DTE Energy - Michigan Consolidated Gas Company
Data Integrity and Technology, Drafting Department
One Energy Plaza, WCB-1836, 18TH Floor
City of Detroit, MI 48226

RE: Petition No. 316 Dated: 10/07/2014

NOTICE OF PROPOSED CHANGE IN PROPERTY

**REQUEST BERM USE
 INTO CHALMERS AVE.
 AT 11306 CHALMERS AVE.
 (With Parking)**

CITY OF DETROIT CITY ENGINEERING DEPARTMENT SURVEY BUREAU	
JOB NO.	01-01
DRWG. NO.	X 316

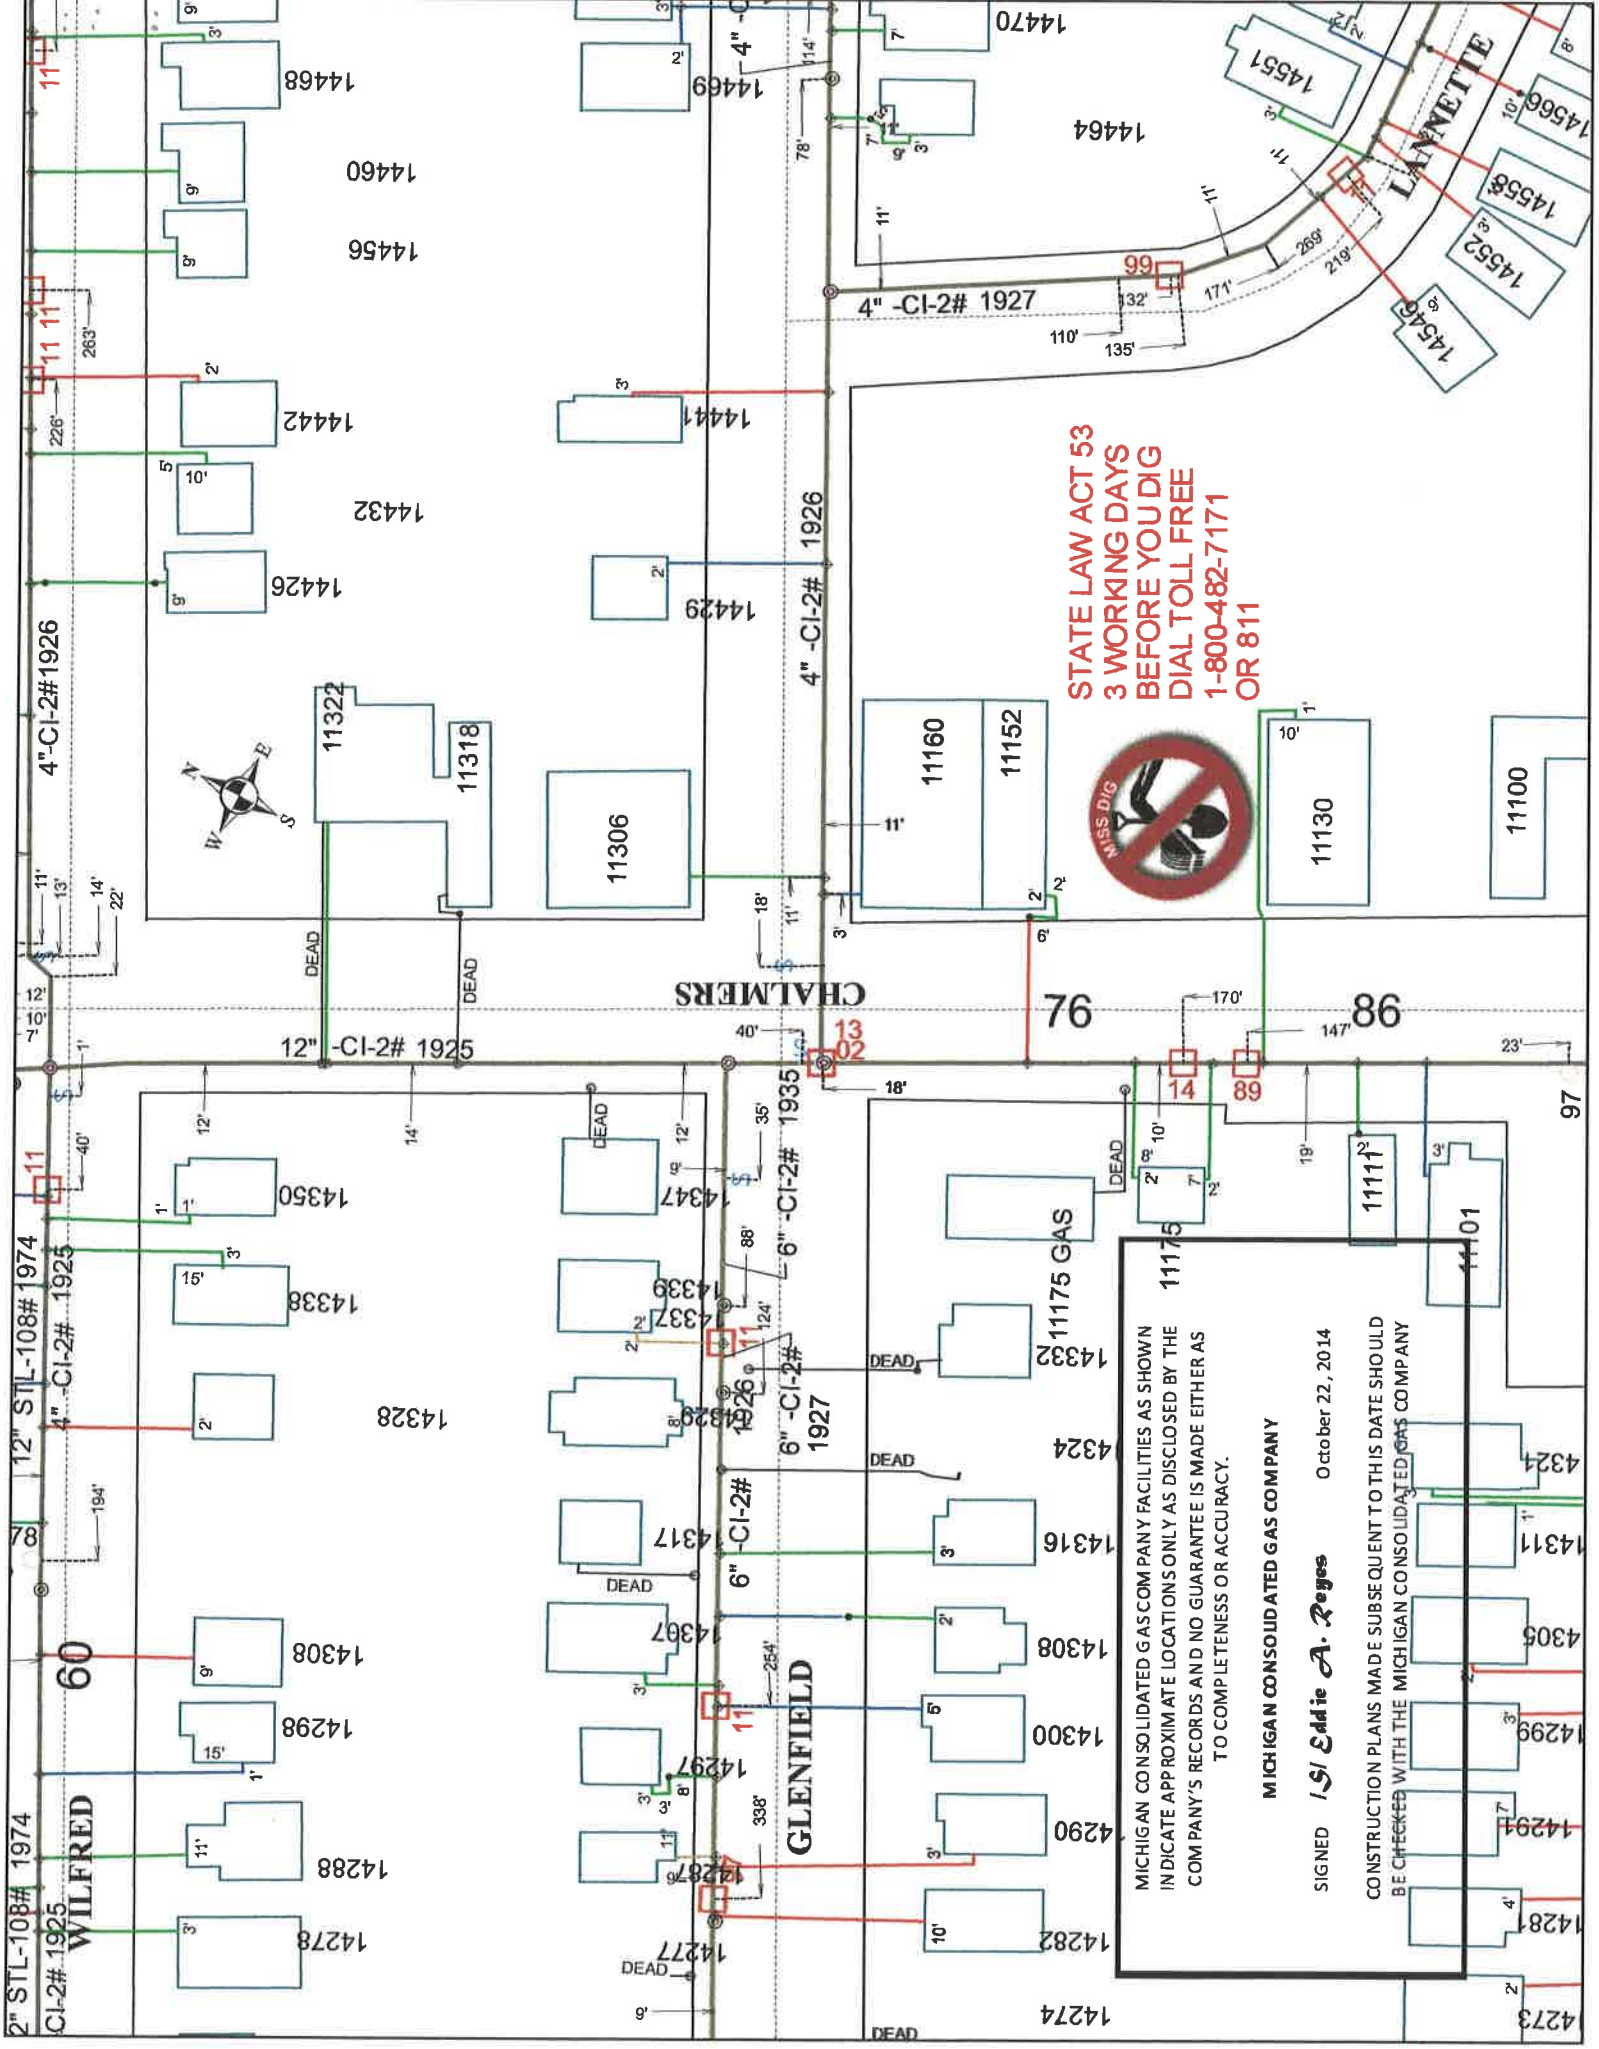
Involved, but have no objection to the property change, provided that an easement of the full width of the Northeast Corner of Chalmers and Glenfield Avenues (at the Address: #11306), are reserved. Also, the clearance between the bottom of the proposed sidewalk/berm and our existing gas main (4"-CI-2# 1926, as shown on our map or print) will be at least a minimum of 5' vertically. Otherwise, contact our Public Improvement Department for the estimated cost of our services in abandoning, removing, relocating, and/or rerouting, including the survey, design, and drawing of our existing utilities (Supervisor: Mr. Michael G. Fedele @ 313-389-7211 or P.I. Gas Planner: Laura D. Forrester @ 313-389-7261). See enclosed strip print for your use and information.
